Item Name: Lower Deflector Assembly, Long

WORK ORDER NON-CONFORMANCE / UPDATE

APICAL INDUSTRIES, INC.	ENGINEERING CHANGE NOTICE NO. 04389				SHEET 1 OF 1
	DWG NO. 647.9400	REV: A	PREPARED BY J. SOTO	DATE: 01/28/2014	EFFECT ON DWG ☒ INC. ☐ UNINC.
	DWG TITLE: DEFLECTORS				
	APPROVED BY: ENGR	MFG	QC	EFF. NEXT ORDER	
TRANSACTION CODES (TC): A-ADD C-CREATE R-REVISE D-DELETE	REASON: REVISED, ADDED, & DELETED INSPECTION DIMENSIONS TO 647.9414.				ECR: D-14-01

DEFLECTORS

647.9415

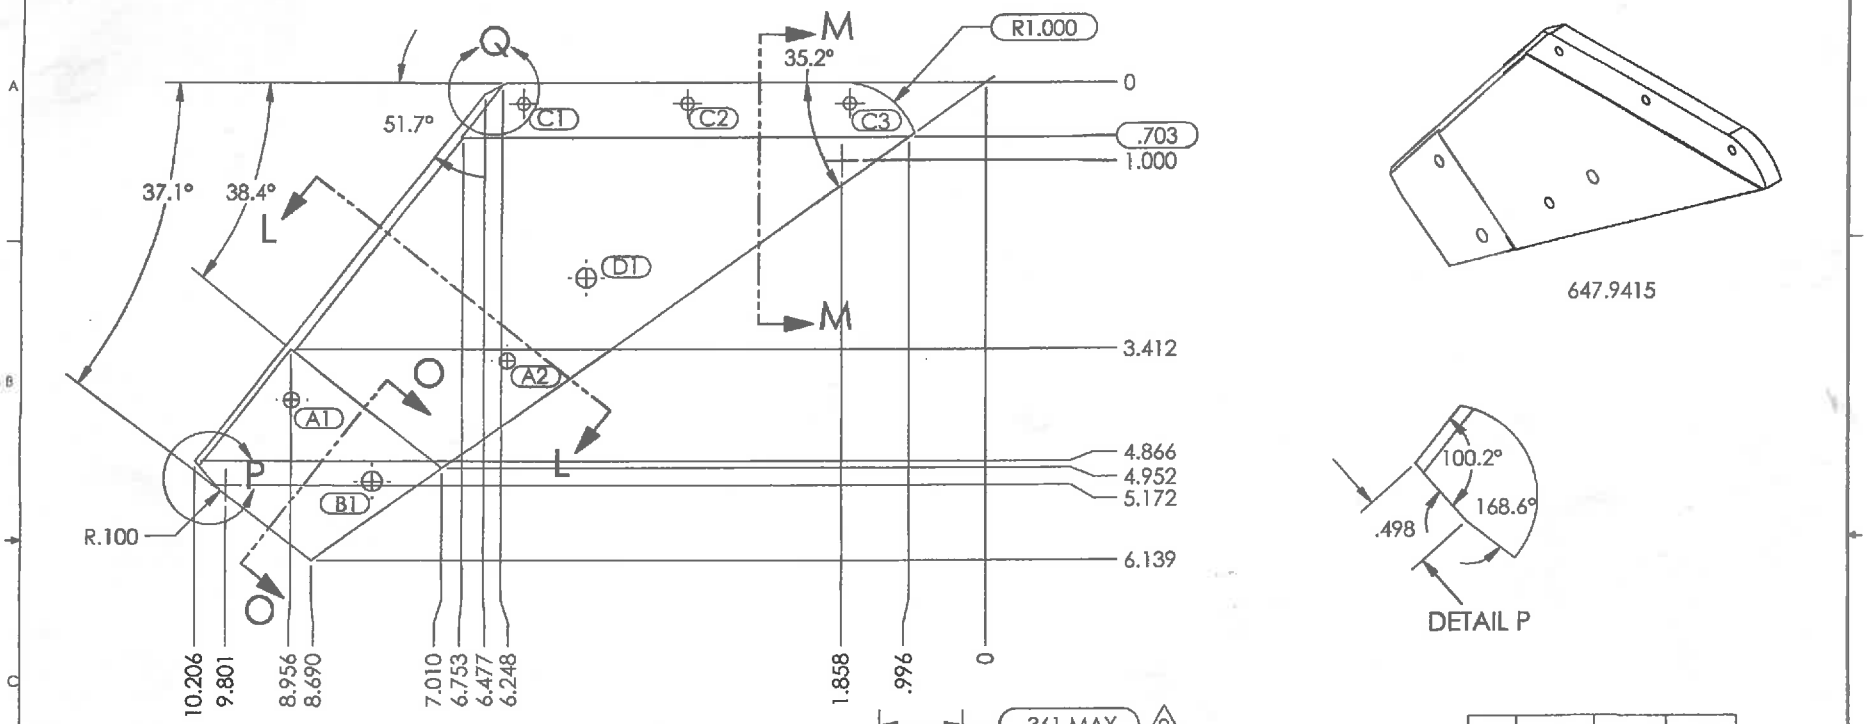
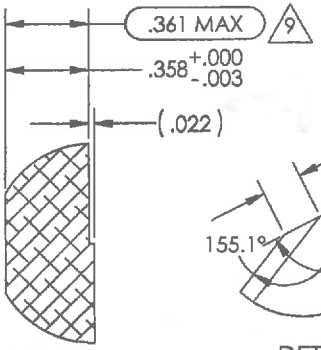
Root Cause		Date	Step	Qty	Description of work order update or non-conformance	Initial Chief Eng	Action Description	Sign & Date	Verification	QC Inspector
Design	☐	15681A	110	2	Hole (B1) on 647,9415 is at 0,249Ø. should be 0,253Ø. Those parts where purchased from Apical.	DAS 9 9-89 15-10-20	Rework part. Open (B1) hole to 0,253"Ø. - Realodine hold	DAS 15/08/19 DAS 38 9-89 OCT 13 2015	DAS 38 9-89 OCT 13 2015	DAS 9 9-89 15-10-20
Doc/Data	☐									
Equip/Tooling	☐									
Handling/Pre	☐									
Material	☒									
Operator	☐									
Offset/Setup	☐									
Process	☐									
Supplier	☐									
Training	☐									
Transport	☐									
Unapproved	☐

TAG	X LOC	Y LOC	SIZE
A1	-8.949	-4.066	Ø.201
A2	-6.172	-3.562	Ø.201
B1	-7.903	-5.121	Ø.253
C1	-5.978	-.267	Ø.165
C2	-3.863	-.267	Ø.165
C3	-1.758	-.267	Ø.165
D1	-5.159	-2.500	Ø.250
